S.L. CHASSE STEEL AMENDED SITE PLANS – **201 & 199 ROBINSON ROAD**

SP# 10-22 (AMENDMENT TO SP# 03-21)

SP# 11-22 (AMENDMENT TO SP# 04-21)

STAFF REPORT

DATE: APRIL 6, 2021 SCALE: 1" = 40'
 PROJECT NO: 20-0921-2 SHEET 3 OF 16

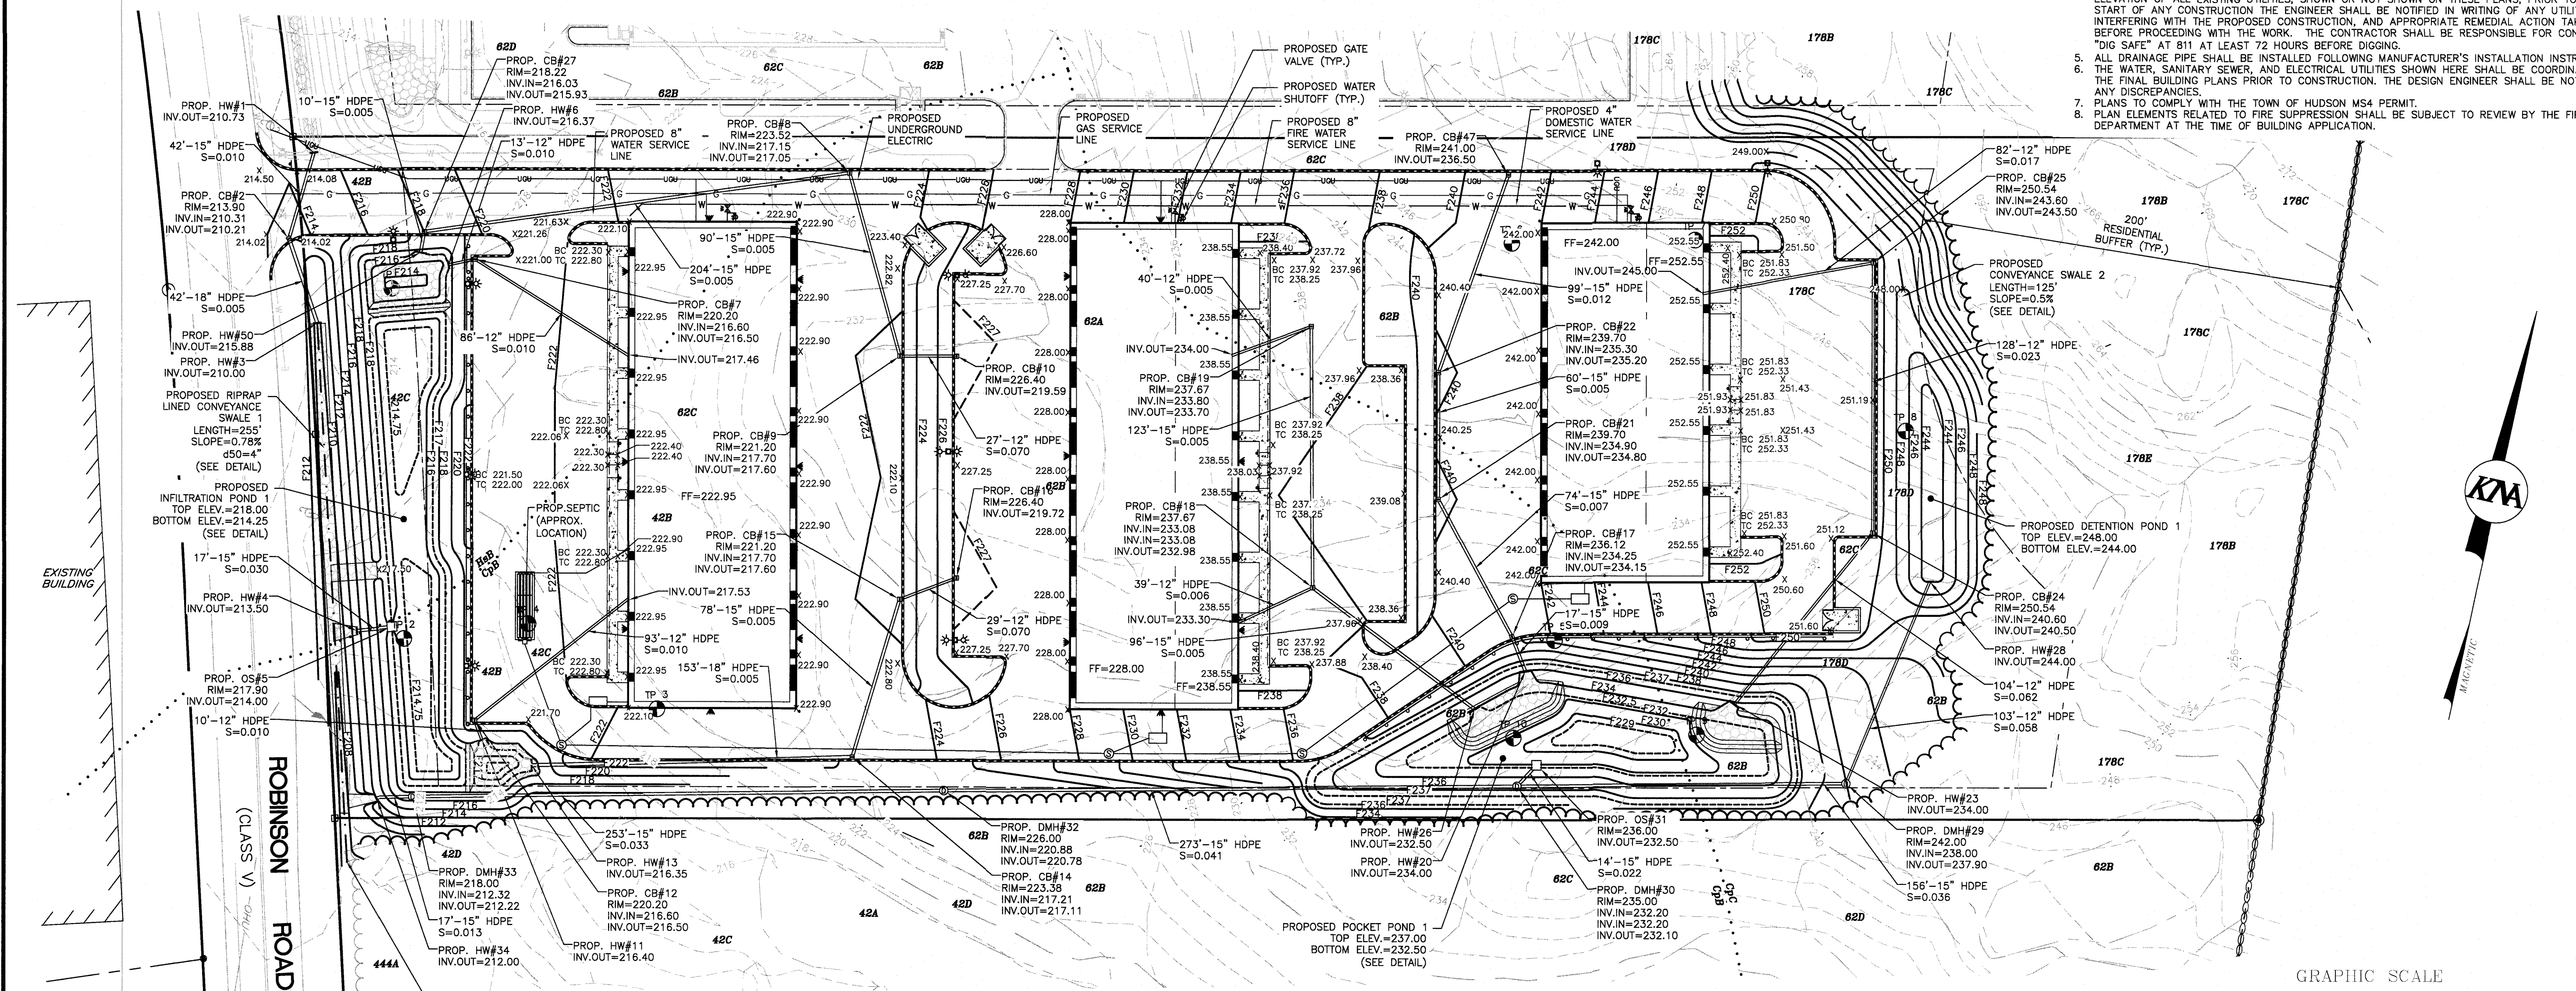
- b. (Lot 17-3) Site Plan Sheet 3 has “proposed outlet structure” and “proposed drain manhole” leader notes south of Building #3 that do not point to the structures.

- b. *(Lot 17-3) Site Plan Sheet 3 has “proposed outlet structure” and “proposed drain manhole” leader notes south of Building #3 that do not point to the structures.*

- b. *Former Fuss & O'Neill Comment: (Lot 17-3) Site Plan Sheet 3 has "proposed outlet structure" and "proposed drain manhole" leader notes south of Building #3 that do not point to the structures.*
Current Fuss & O'Neill Comment: The applicant has revised the leader lines. No further Fuss & O'Neill comment.

Leaders have been revised.

DATE: APRIL 6, 2021 SCALE: 1" = 40'
PROJECT NO: 20-0921-2 SHEET 7 OF 16

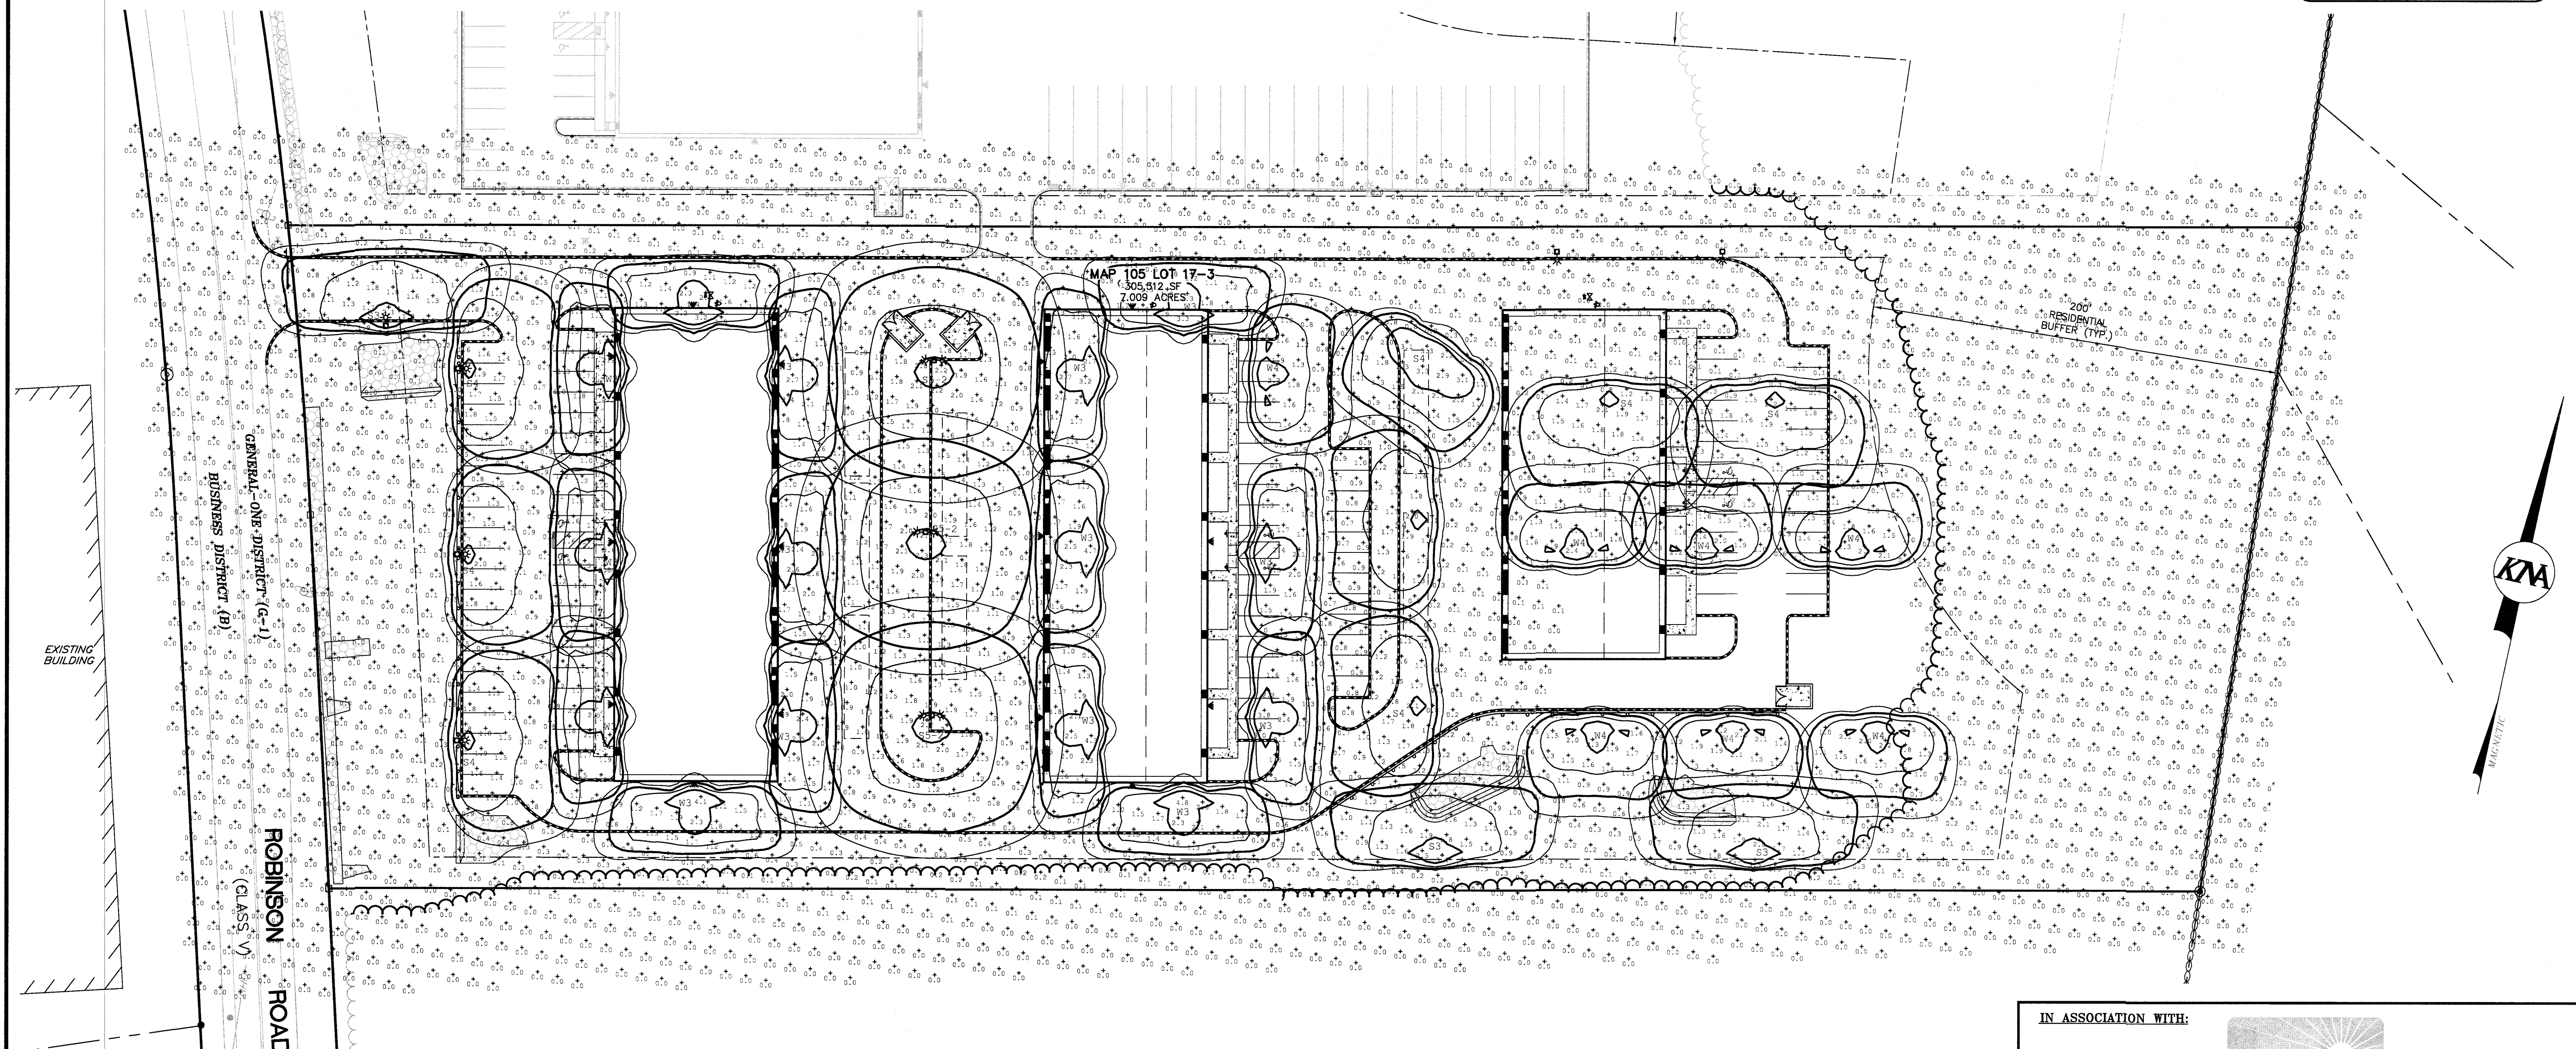
- c. (Lot 17-3) The proposed invert in (240.50) to CB #24 is lower than the proposed invert out (240.60). The applicant should review and revise this grading.

c. (Lot 17-3) The proposed invert in (240.50) to CB #24 is lower than the proposed invert out (240.60). The applicant should review and revise this grading.

- c. *Former Fuss & O'Neill Comment: (Lot 17-3) The proposed invert in (240.50) to CB #24 is lower than the proposed invert out (240.60). The applicant should review and revise this grading.*
Current Fuss & O'Neill Comment: The applicant revised the inverts on Plan Sheet 7 (bottom right of parking lot). No further Fuss & O'Neill comment.

- d. *Former Fuss & O'Neill Comment: (Lot 17-3) DMH #30 has two proposed inverts in and no invert out.*
Current Fuss & O'Neill Comment: The applicant has revised the inverts on Plan Sheet 7 (above the site specific soil map unit key). No further Fuss & O'Neill comment.

Inverts for CB #24 have been revised on both plan and storm calculations.

Plan has been revised to show DMH #30 invert out.
